REED'S COVE 3RD ADDITION

RE: SUB 2004-08 -- Final Plat of Reed's Cove Third Addition

CASE NUMBER: SUB 2004-08 -- REEDS COVE THIRD ADDITION

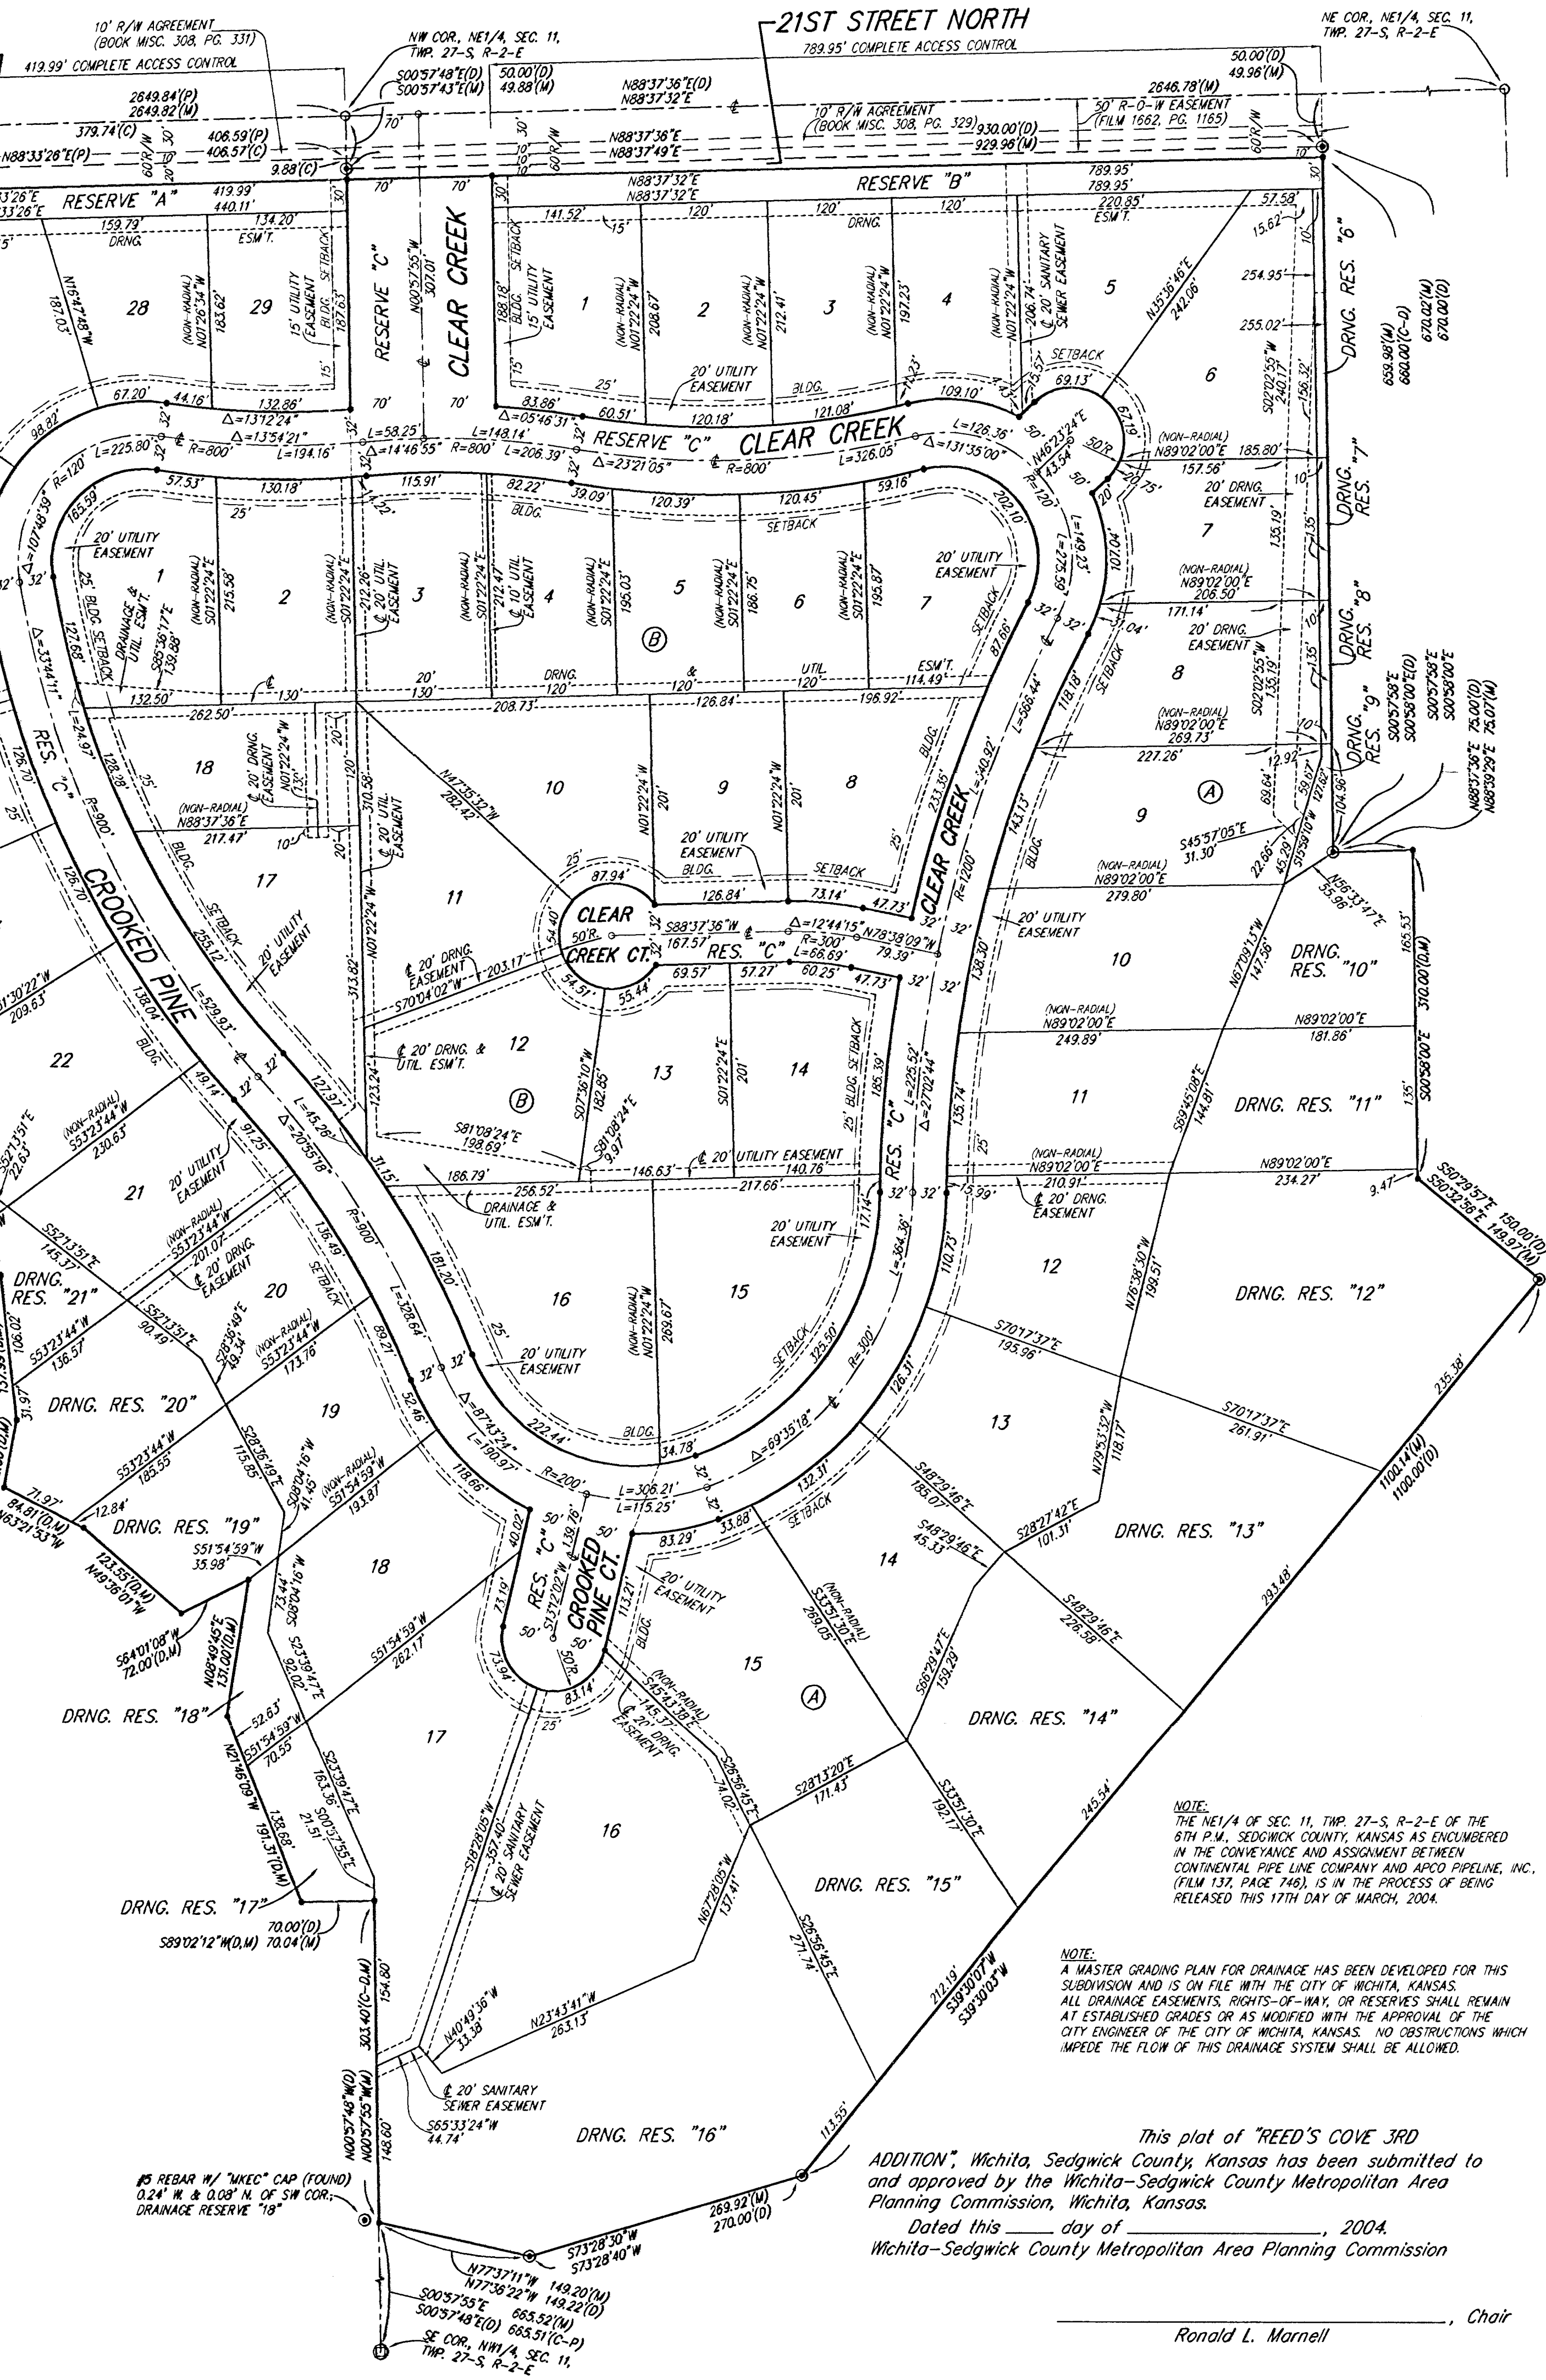
- A. Prior to this plat being scheduled for City Council review, annexation of the eastern portion of the property will need to be completed. Upon annexation, the property will be zoned SF-5, Single-Family Residential.

- B. The applicant shall guarantee the extension of sanitary sewer and City water to serve the lots being platted. City Water and Sewer Department and OCI have requested an agreement which limits sewer connections based upon capacity.

- D. City Engineering needs to comment on the status of the applicant's drainage plan. The drainage plan is approved. A guarantee is needed.
- E. Traffic Engineering has requested a petition for a left-turn lane.

- G. City Fire Department has requested a 35-ft roadway be provided at the street entrance. In the event a median is used, a 20-ft roadway for ingress and 29-ft roadway for egress shall be provided. If a gated development is proposed, a siren-activation gate is needed.

- I. A covenant shall be submitted regarding the private street, which sets forth ownership and maintenance responsibilities. The plat's text shall reference the platting of the reserve for private street purposes and shall state which specific lots are to be accessed by the reserve.

- J. The reserves being platted as private streets shall be shown appropriate street names.
- K. In accordance with the KS Wetland Mapping Conventions under the Memorandum of Understanding between the USDA-NRCS; USEPA; USACE; and USF&WS, this site has been identified as one with potential wetland hydrology. The US Army Corps of Engineers (USACE) should be contacted (316-322-8247) to have a wetland determination completed."

- N. The drainage reserves "20" through "29" need to be referenced in the plat's text.
- O. GIS needs to comment on the plat's street names. *The entrance should be Clear Creek. The loop street should be Crooked Pine and Clear Creek.*

- P. A bold solid line is needed between the 21st St. North right-of-way line and Reserve C.
- Q. County Surveying advises that the benchmark needs a better description.

- R. The Applicant needs to verify the location of the pipeline easement indicated in the platting binder. The easement shall be shown if encumbering this plat, or verification provided that it is off-site or has been released.

- S. The plat's text shall include language that a drainage plan has been developed for the plat and that all drainage easements, rights-of-way, or reserves shall remain at established grades or as modified with the approval of the applicable City or County Engineer, and unobstructed to allow for the conveyance of stormwater.

- AA. The representatives from the utility companies should be prepared to comment on the need for any additional utility easements to be platted on this property. Westar Energy and SBC have requested additional easements.
